Overhead Door Company
Reed Door Company
Holland ME

Revision Hand Rail Detail 2/9/17

Hand Rail Detail
1 1/4" Round Steel Pipe
Schedule 40 (1.66 dia)
* Rail Heights & materials
Same Both Sides

Building Permit #
2016-02842

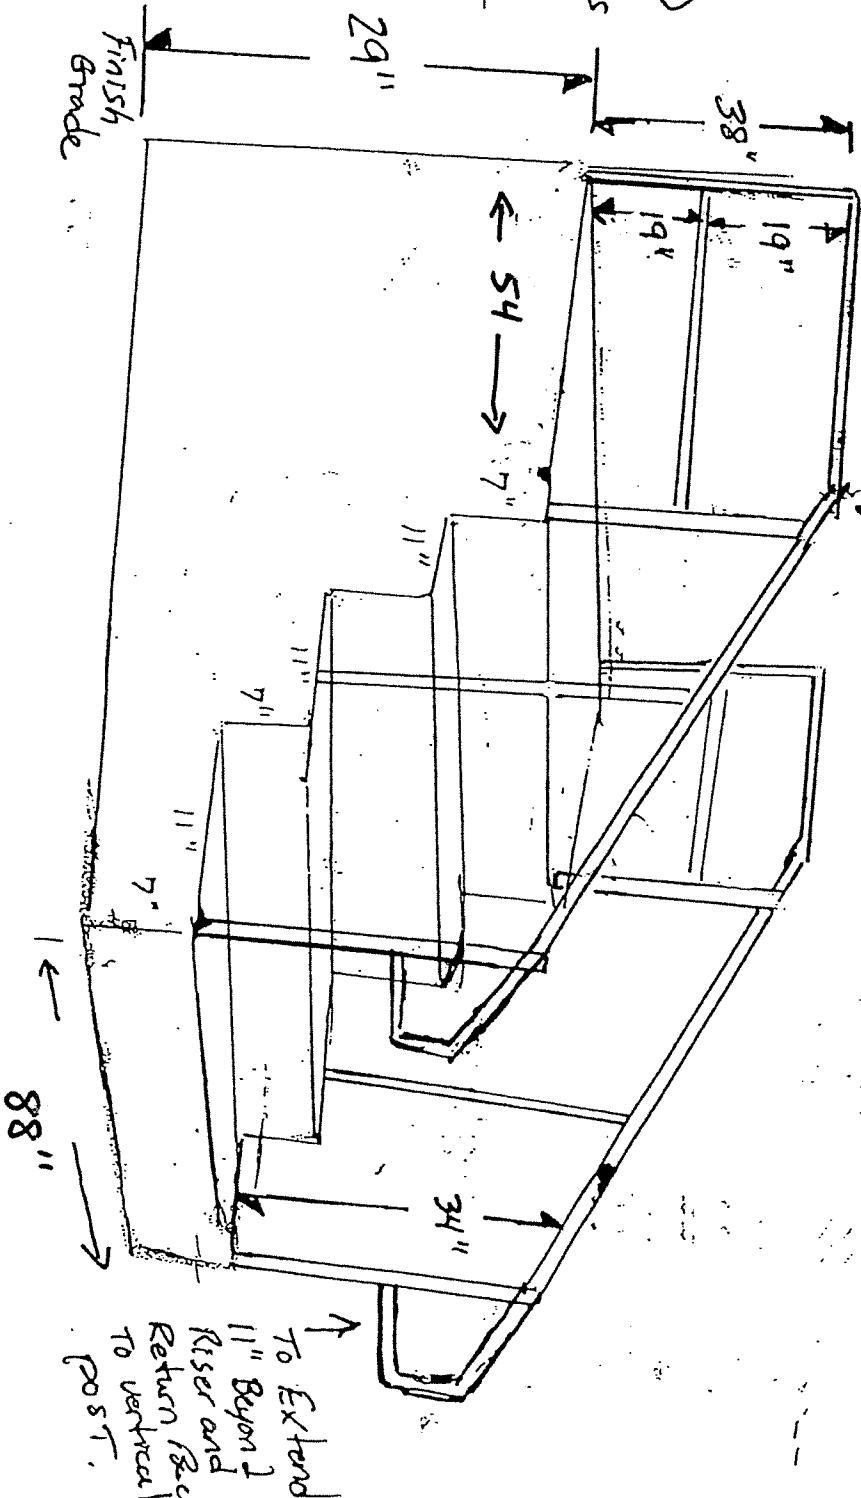
* Extends 12" Beyond Top Riser
Rail continues to post

* Revision 4/11/17 Stair width & landing area Depth

Change - concrete forms need to be set so that
Landing Depth is 54" and stairs width will be
88"
